Product Change Notification / ALAN-08K00J271

CCB 4767 Final Notice: Qualification of ANAP as an additional assembly site for selected Atmel AT91SAM7S1xx and AT91SAM7S2xx device families in 64L LQFP (10x10x1.4mm) package.

CCB 4767

Pre and Post Change Summary

Pre Change

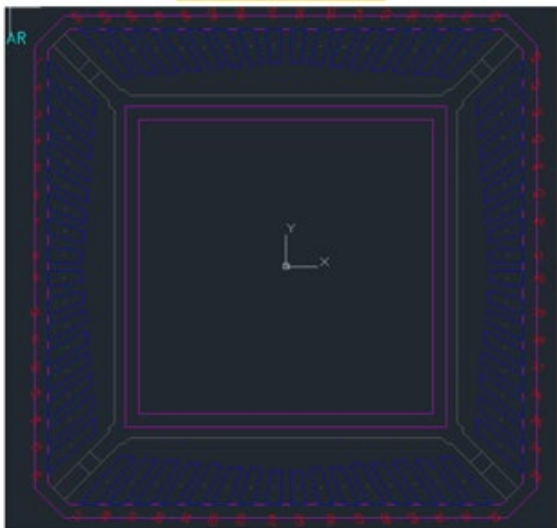
Assembly location		ASE Inc. (ASEK)
Die attach material		CRM-1076WA
Mold compound material		G631HQ
Lead frame material	Material	C7025
	Process	Stamped

Post Change

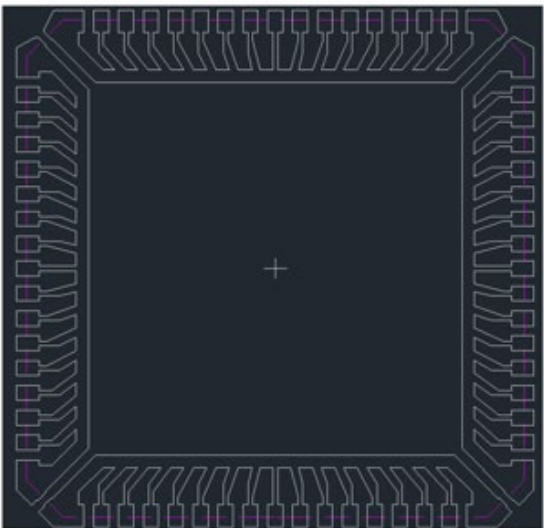
Assembly location		Amkor Technology Philippine (P1/P2), INC. (ANAP)
Die attach material		3230
Mold compound material		G631HQ
Lead frame material	Material	C194
	Process	Etched
